Model: Bellini-C2		Date: 25-Mar-03	No.: MB070001
Modified Article: Transport Screw: T=20		Prepared by: F.Noguchi	
From: Technical Services Sec. Service Planning Dept.			
Reason for Modification:	☒ Parts catalog correction ☐ To facilitate assembly ☐ Part standardization	☐ Vendor change ☐ To improve reliability ☐ Other	☐ To meet standards ()

Model: Bellini-C2		Date: 11-Apr-03	No.: MB070002
Modified Article: ARDF		Prepared by: F.Noguchi	
From: 2nd Tech. Support Sec. Service Support Dept.			
Reason for Modification:	☒ Parts catalog correction ☐ To facilitate assembly ☐ Part standardization	☐ Vendor change ☐ To improve reliability ☐ Other	☐ To meet standards ()

Section 37. DEVELOPMENT UNIT 2 (B070/B071)

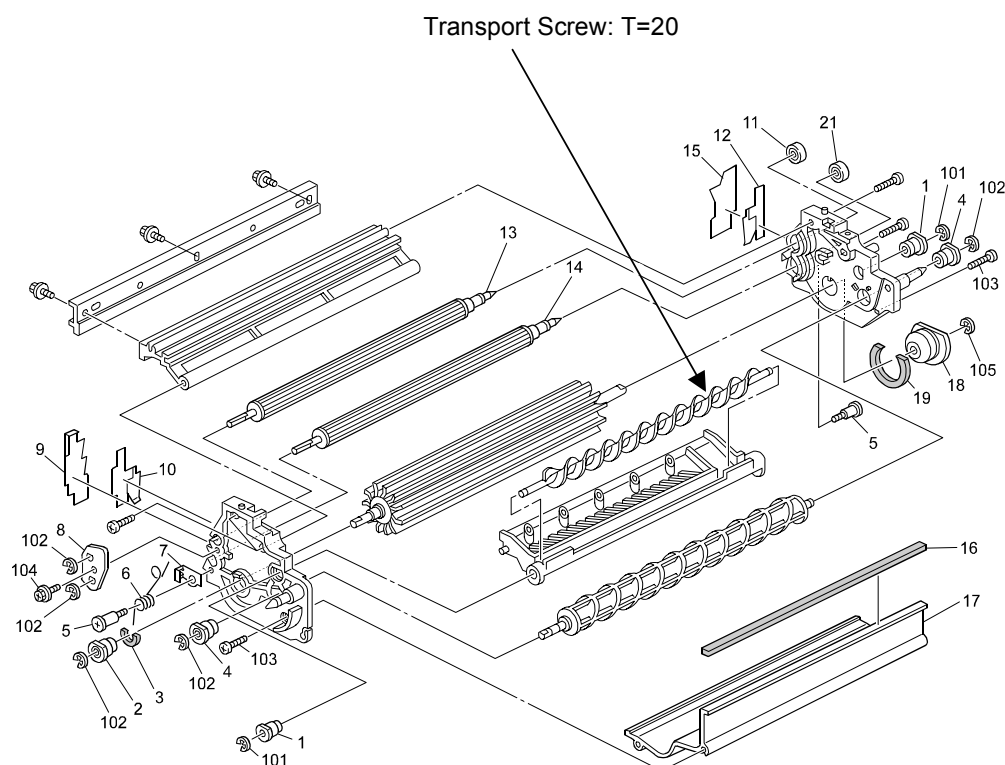
The following has been newly registered as a service part for individual replacement in the field.

New part number	Description	Q'ty	Page	Index	Note
B0703119	Transport Screw: T=20	1	89	*20

Section 7. ORIGINAL FEED (B070/B071)

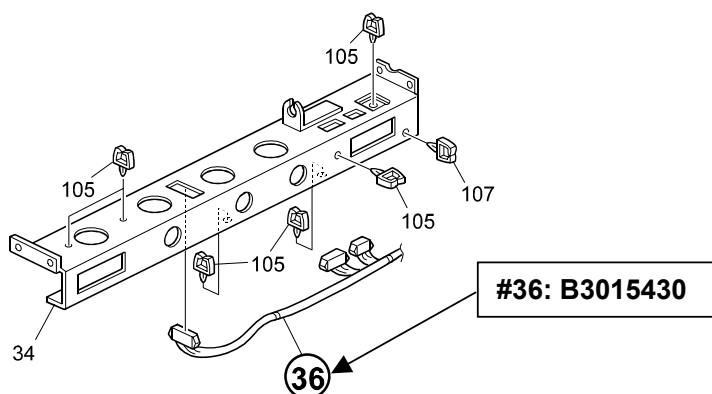
Part number	Description	Q'ty	Page	Index
Added	B3015430	DC Harness	1	29	36

Section 8. ORIGINAL FEED 3 (B070/B071)

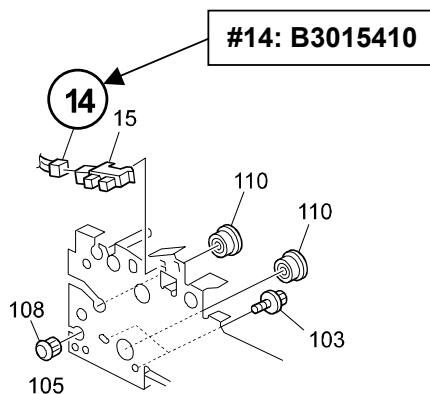
Part number	Description	Q'ty	Page	Index
Incorrect	B3015455	DC Relay Harness	1	31	14
Correct	B3015410	Harness: Connecting: Paper Feed	1	31	14

Section 10. ORIGINAL EXIT 1 (B070/B071)

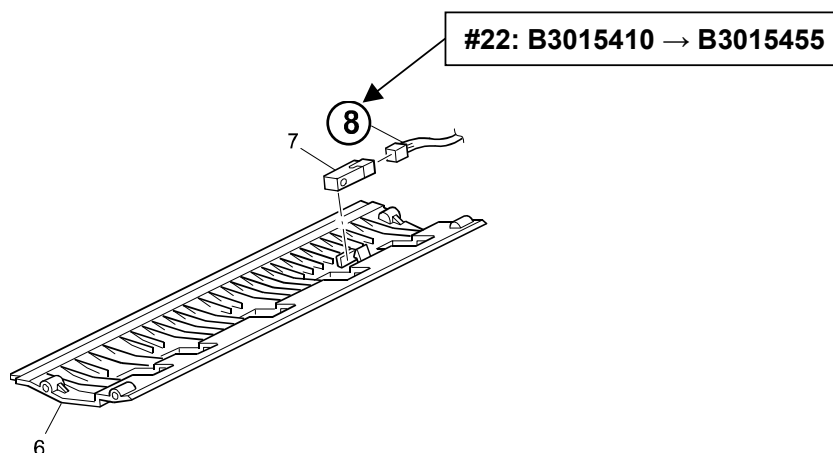
Part number	Description	Q'ty	Page	Index
Incorrect	B3015410	Harness: Connecting: Paper Feed	1	35	8
Correct	B3015455	DC Relay Harness	1	35	8

Section 13. DF DRIVE SECTION (B070/B071)

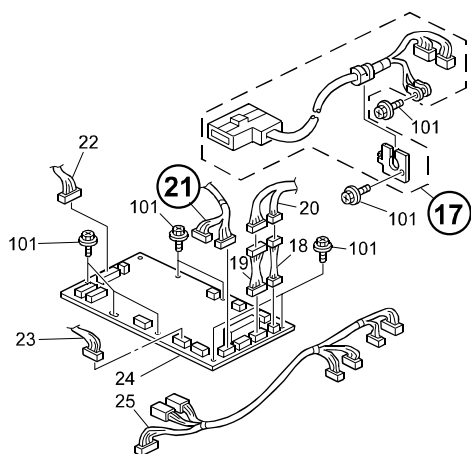
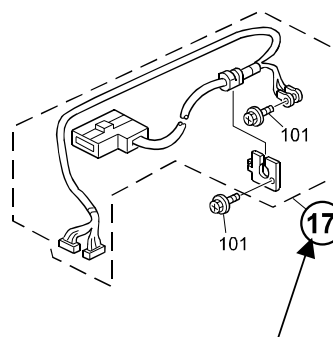
Part number	Description	Q'ty	Page	Index
Deleted	B3015430	DC Harness	1	41	21

#17: Corrected illustration
#21: Deleted

Section 39. PCU 1 (B070/B071)

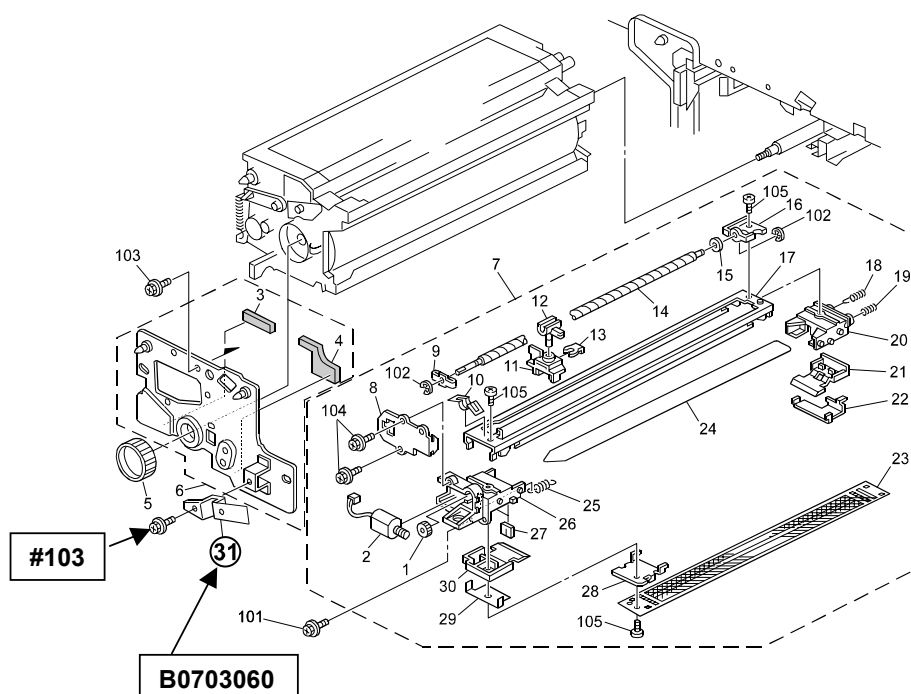
Part number	Description	Q'ty	Page	Index
<i>B0703060</i>	<i>Plate: Drum Stay: Ass'y</i>	<i>1</i>	<i>93</i>	<i>*31</i>

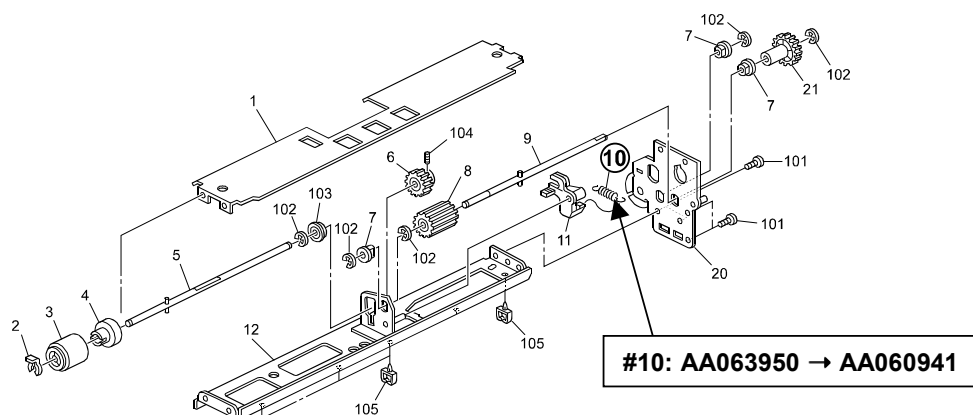
The Reverse Pressure Spring has been changed as follows to improve paper feed performance.

- Pressure increased
- Diameter increased (0.45mm→ 0.5mm)
- Pre-attachment length increased (18.0mm→ 21.4mm).

Old part number	New part number	Description	Q'ty	Int	Page	Index	Note
AA063950		Pressure Spring	3 - 3	X/O	67	10	
	AA060941	Spring: Pressure: Reverse

Section 36. DEVELOPMENT UNIT 1 (B070/B071)

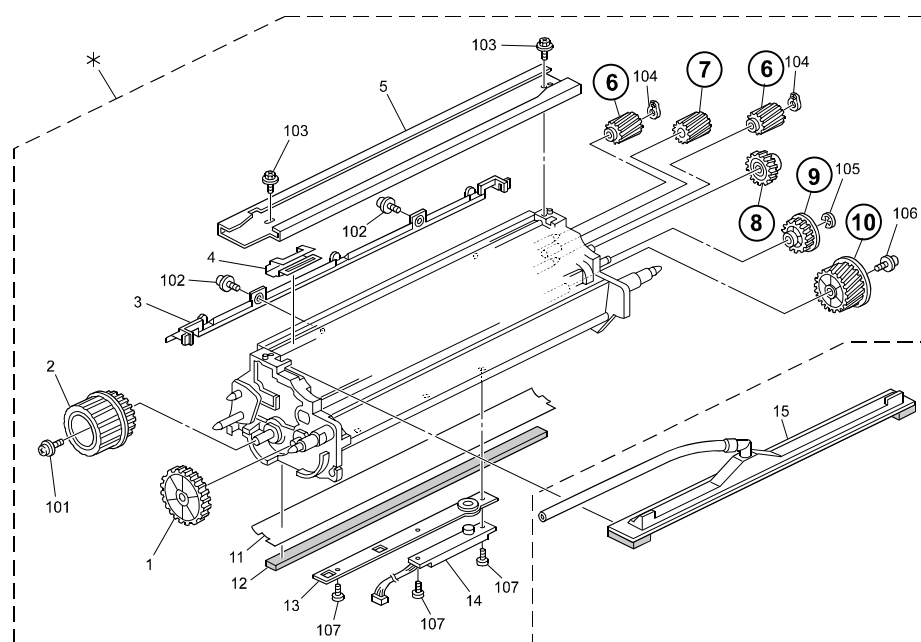
The following development unit gears have been changed to allow the gear teeth to engage more smoothly, providing smoother rotation.

Note: Since the number of teeth have been increased, when installing any of the new gears for the first time, it is necessary to install **all gears together as a set**.

Old part number	New part number	Description	Q'ty	Int	Page	Index	Note
B0703100	B0703101	Development Unit: Ass'y	1 - 1	X/O	87	*	
A2473081		Gear - 17Z	2 - 2	X/X	87	6	**
	B0703180	Gear: Development Roller: Z21: M=0.8					
AB013786		Gear - 18Z	1 - 1	X/X	87	7	**
	B0703181	Gear: Idler: Z23: M=0.8: Ass'y					
AB013788		Gear - 23Z	1 - 1	X/X	87	8	**
	B0703184	Gear: Idler: Z29: M=0.8: Ass'y					
AB013790		Gear - 25Z	1 - 1	X/X	87	9	**
	B0703186	Gear: Transport Screw: Z31: M=0.8					
A2473074		Gear - 34Z	1 - 1	X/X	87	10	**
	B0703183	Gear: Paddle: Joint: Z42: M=0.8

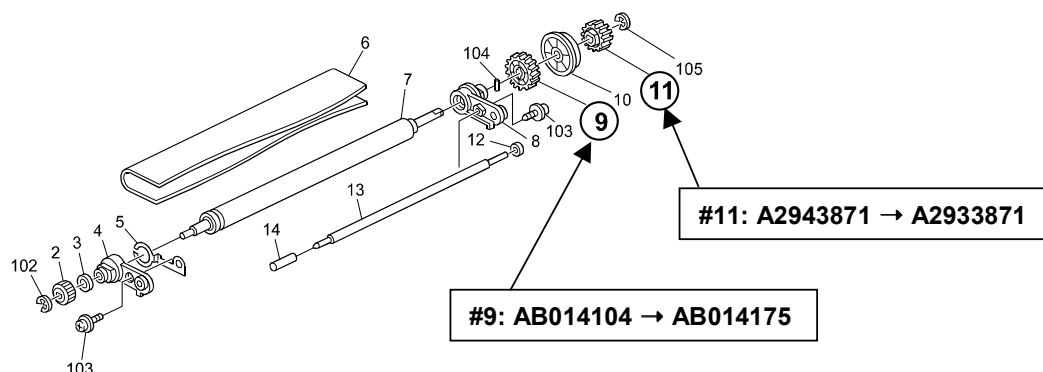
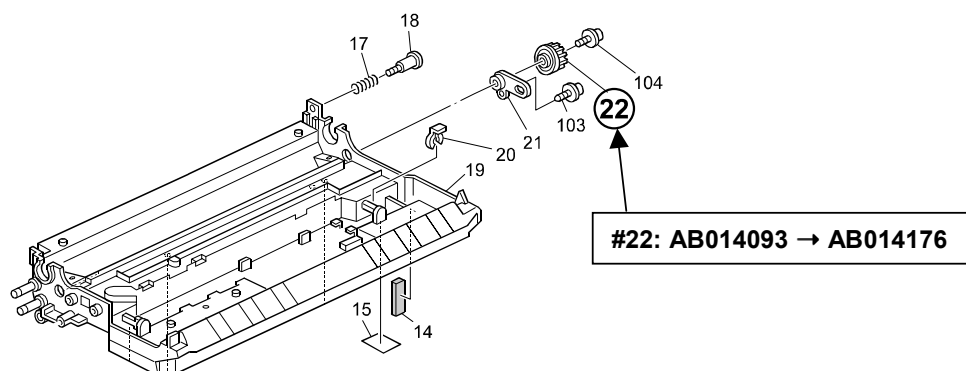
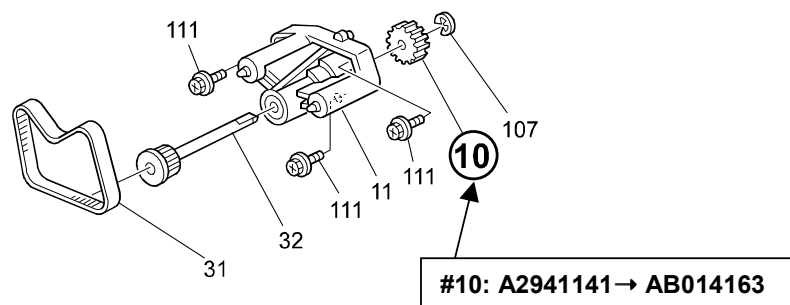
The following gears have been changed to minimize vibration from the transfer belt unit drive section.

Old part number	New part number	Description	Q'ty	Int	Page	Index	Note
A2943871	A2933871	Gear - 20Z	1 - 1	O/O	101	11	
AB014104		Cleaning Roller Gear	1 - 1	X/X	101	9	*
	AB014175	Gear - 50Z					
AB014093		Cleaning Roller Gear	1 - 1	X/X	103	22	*
	AB014176	Cam Gear - 37Z					
A2941141		Gear - 24Z	1 - 1	X/O	133	10	
	AB014163	Drive Gear – Transfer Belt

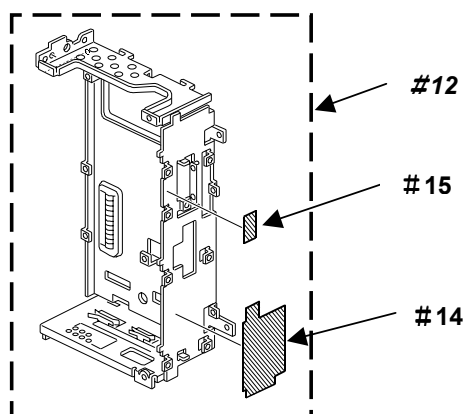
Index: 28 → ***12*** (table)

#26 → ***#12*** (illustration)

An Insulating Sheet has been added to prevent contact between the Control Board Bracket and leads of board components.

Old part number	New part number	Description	Q'ty	Int	Page	Index	Note
B0706865		Bracket: Control Board: Sub Ass'y	1 - 1	X/O	153	<i>12</i>	
	B0706864	Bracket: Control Board: Sheet Ass'y					
	B0706868	Insulating Sheet: Large	0 - 1	-	153	*14	
	B0706869	Insulating Sheet: Small	0 - 1	-	153	*15

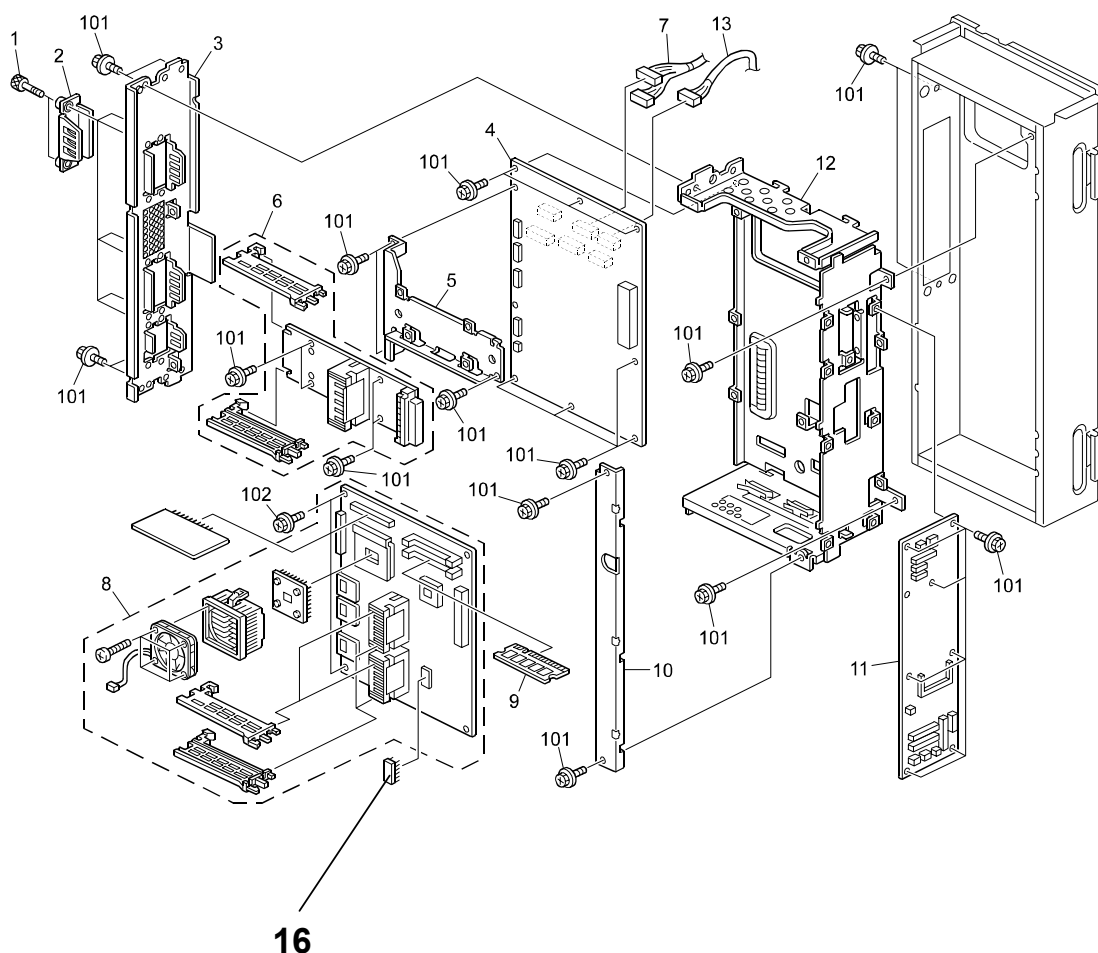
Please add the following item to your Parts Catalogs, which was previously missing.

Old part number	New part number	Description	Q'ty	Int	Page	Index	Note
	B0709590	NVRAM – Zero Counter	1	-	153	*16

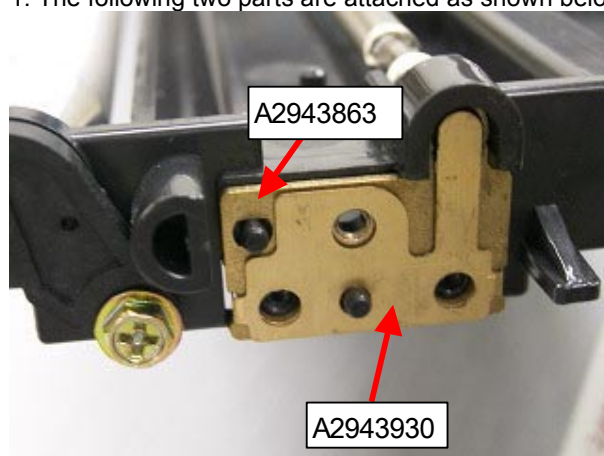
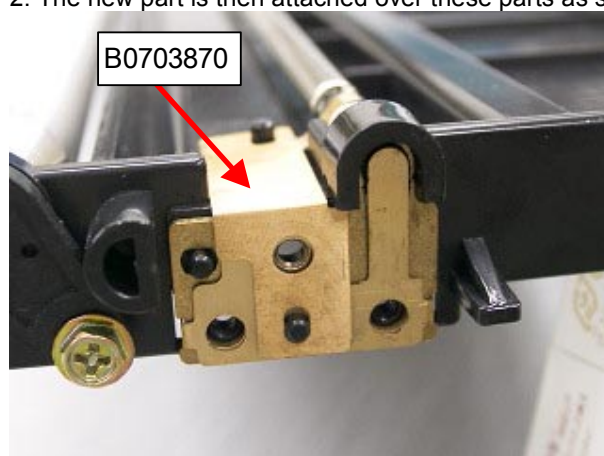
The following has been added to provide greater latitude in satisfying Ricoh internal electrical noise standards.

Old part number	New part number	Description	Q'ty	Int	Page	Index	Note
-	B0703870	Terminal:Bias:Transfer	1	-	101	*26

Note: Please see the attachment position below.

1. The following two parts are attached as shown below (no change).

2. The new part is then attached over these parts as shown.

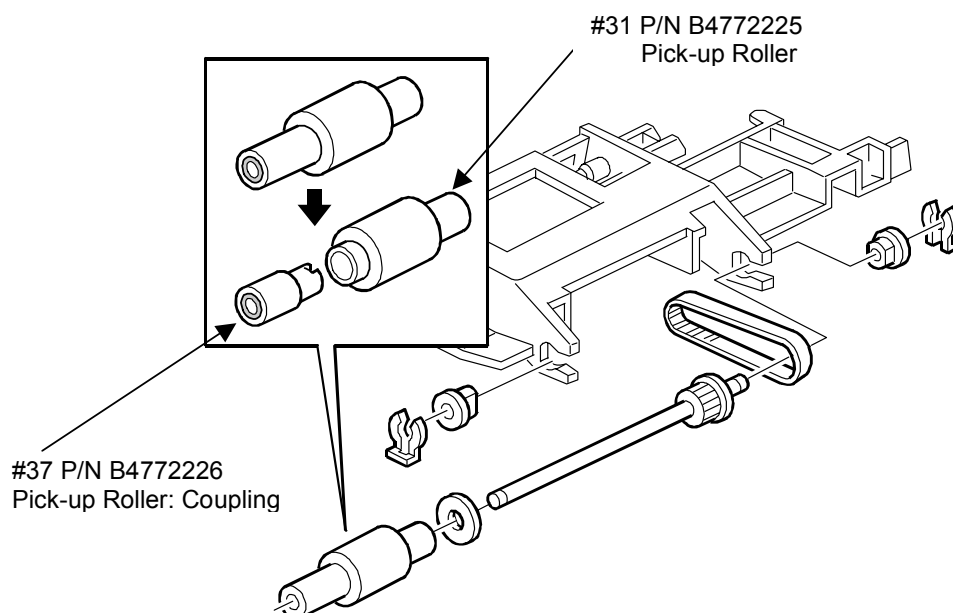
We have corrected the position of the call-out.

Due to parts standardization with a newer model, the "Pick-up Roller" (one-way clutch assembly) has been separated into an individual pick-up roller and clutch.

Although the old assembly must be replaced with both new parts, following this the new parts can be replaced individually.

Old part number	New part number	Description	Q'ty	Int	Page	Index	Note
A8061321		Pick-up Roller	1 - 0	O/	29	31	
	B4772225	Pick-up Roller	0 - 1	/X	29	31	
	B4772226	Pick-up Roller: Coupling	0 - 1	/X	29	*37

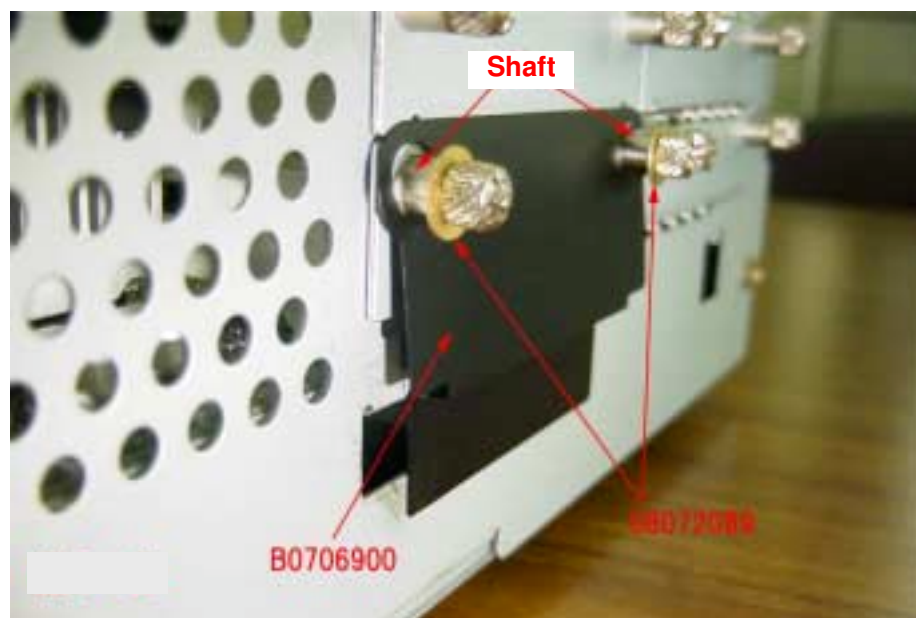
Old part number	New part number	Description	Q'ty	Int	Page	Index	Note
-	B0706900	Shielding Plate: SD Card	1	-	153	*17	
-	08072089	Washer – 10mm	2	-	153	*103

To cover the application SD card slot, a shielding plate has been added as shown below.

B0706667: End fence cover

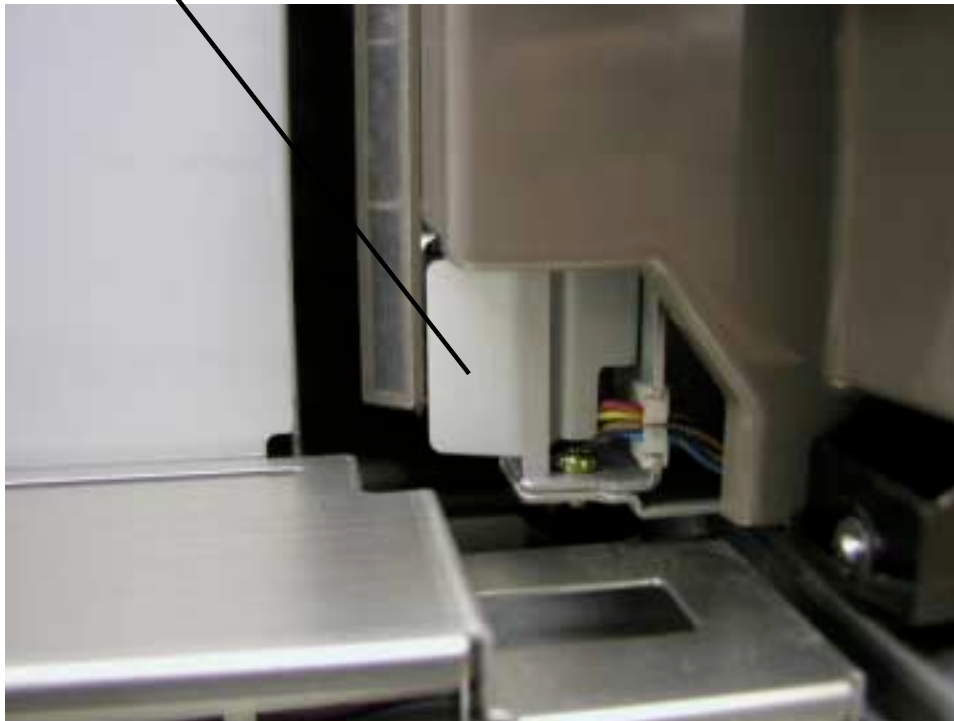
Old part number	New part number	Description	Q'ty	Int	Page	Index	Note
B0706521	B0706523	Tandem LCT:Right:NA:Ass'y	1	X/O	57	1	
B0706520	B0706522	Tandem LCT:Right:Ass'y	1	X/O	57	1	
A2946668	B0706668	Side Plate:Tandem:Right Front	1	X/O	59	27	*1
-	B0706667	End Fence Cover Front	1	X/O	59	*42	*1

If the user sets approximately 150 sheets of paper in the left tandem tray incorrectly, the paper stack may hit the lower part of the end fence. This can damage the end fence. To prevent this, a new cover has been added as shown below.

****New joint holder****

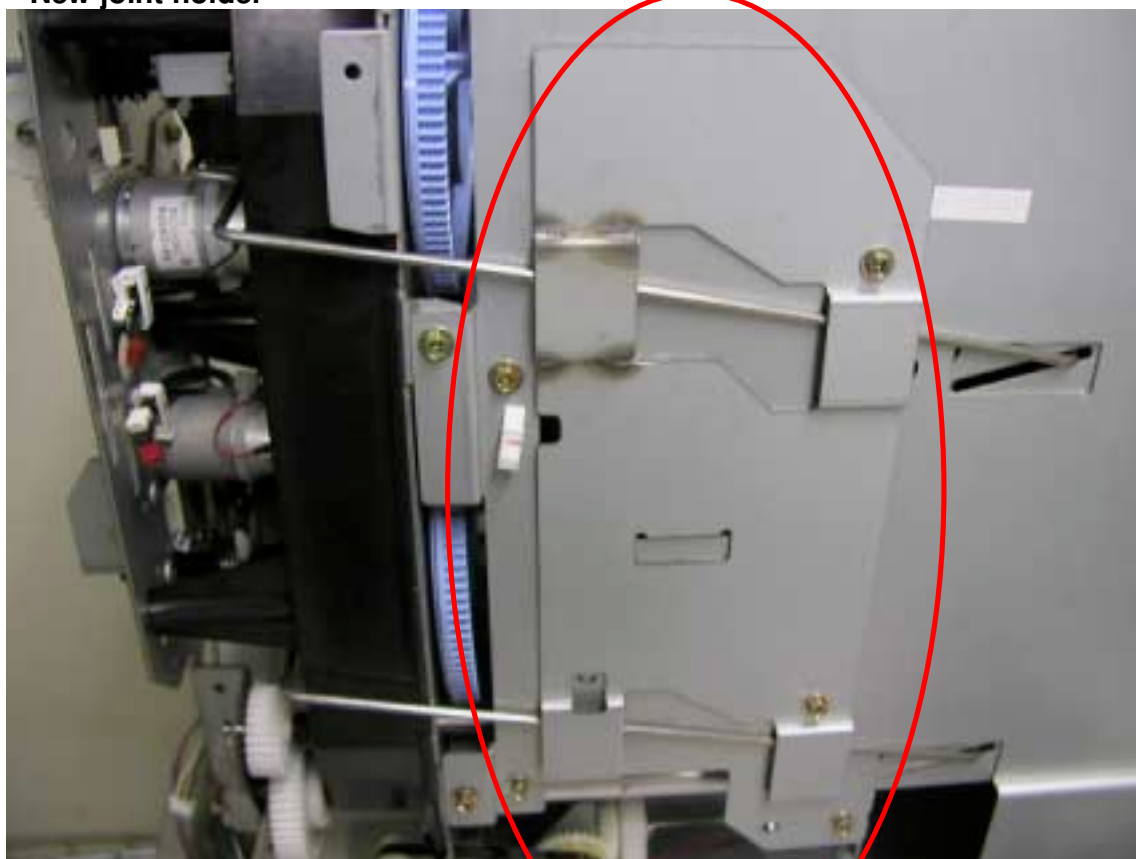
The shape of the joint holder has been changed to ensure the lever rack joint does not slip.

< B0701357 >

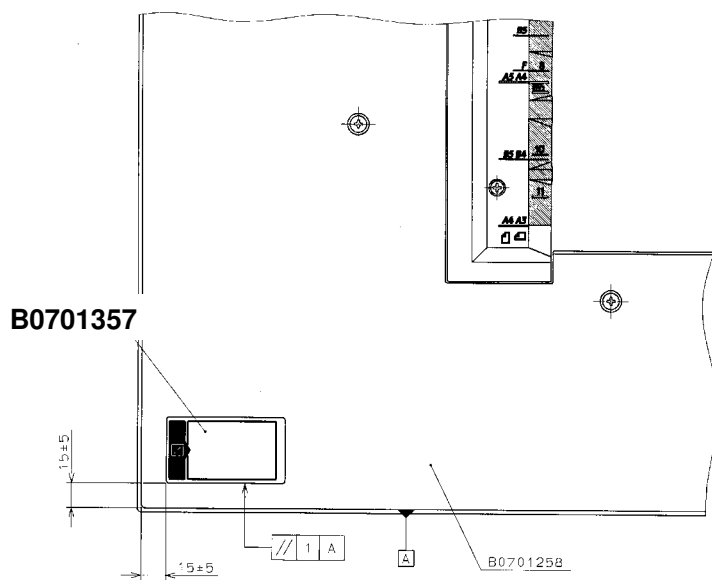
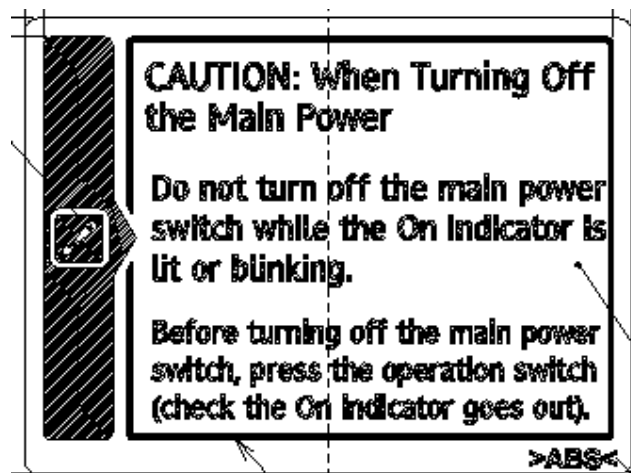
A new decal has been attached on the upper cover as shown below.
